UNITED STATES  
NUCLEAR REGULATORY COMMISSION  
WASHINGTON, D. C. 20555

The Commission has issued the enclosed Amendment No. 48 to Facility Operating License No. NPF-2 and Amendment No. 39 to NPF-8 for the Joseph M. Farley Nuclear Plant, Unit Nos. 1 and 2, respectively. The amendments consist of changes to the Technical Specifications in response to your application transmitted by letter dated March 1, 1984.

JOSEPH M. FARLEY NUCLEAR PLANT, UNIT NO. 1

SAFETY EVALUATION BY THE OFFICE OF NUCLEAR REACTOR REGULATION  
RELATED TO AMENDMENT NO. 48 TO FACILITY OPERATING LICENSE NO. NPF-2  
AND AMENDMENT NO. 39 TO FACILITY OPERATING LICENSE NO. NPF-8

Figure 6.2-2 Facility Organization

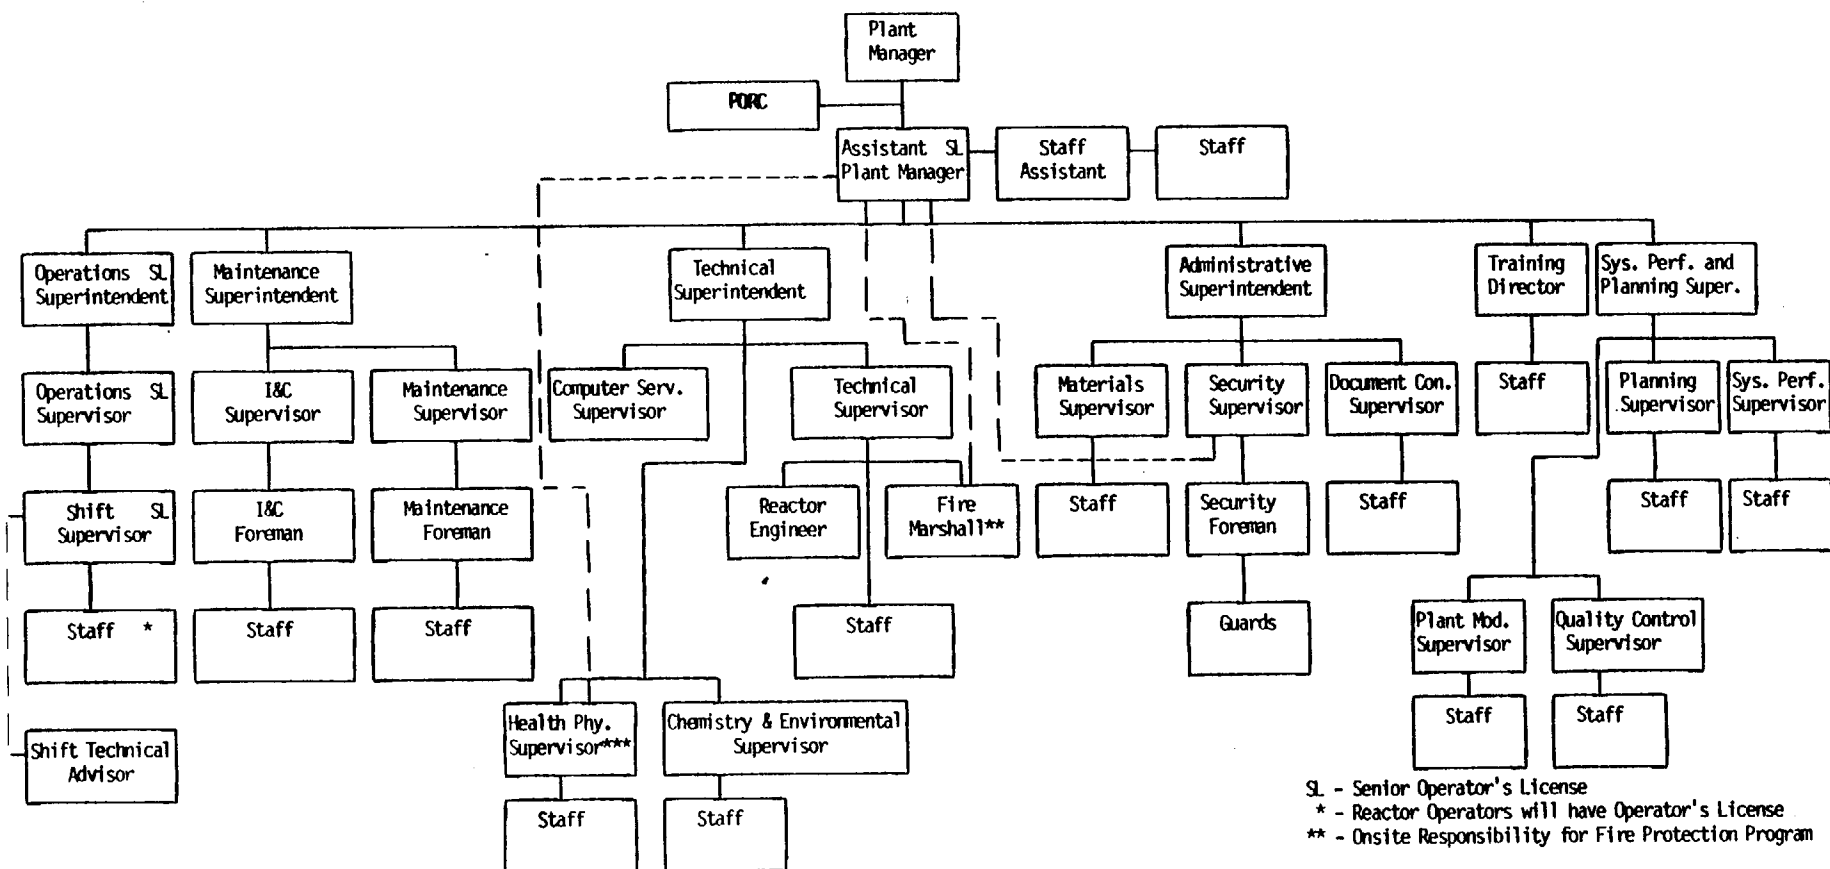
The amendments modify the Technical Specifications to correct errors in Table 4.3-1 (Units 1 and 2), Table 3.6-1 (Units 1 and 2), Table 3.6-1 Section D (Unit 1), and specification 3.7.11.1.c. Also Figure 6.2-2 (Units 1 and 2) is modified to reflect changes in the organizational chart changing the title of the chemistry supervisor and adding a computer services supervisor to the chart.

In their letter of March 1, 1984, APCo proposed several changes to the facility organization. The most significant of these were a change in the title of the Chemistry Supervisor to Chemistry and Environmental Supervisor; and the addition of a Computer Services Supervisor to the organization. No significant responsibility changes were associated with the Chemistry and Environmental Supervisor title change, rather the proposed title more closely reflects the responsibilities of the position. The addition of the Computer Services function reflects the importance the licensee places in this function in supporting the operation of the Farley Nuclear Plant.

Several other minor changes were made to the organization chart including the changes of the title of the Performance and Planning Superintendent to System Performance and Planning Superintendent; and the inclusion in the organization chart of staff personnel reporting to the Planning Supervisor, System Performance Supervisor, Plant Modifications Supervisor, and Quality Control Supervisor.

These proposed changes are purely administrative in nature and are acceptable.
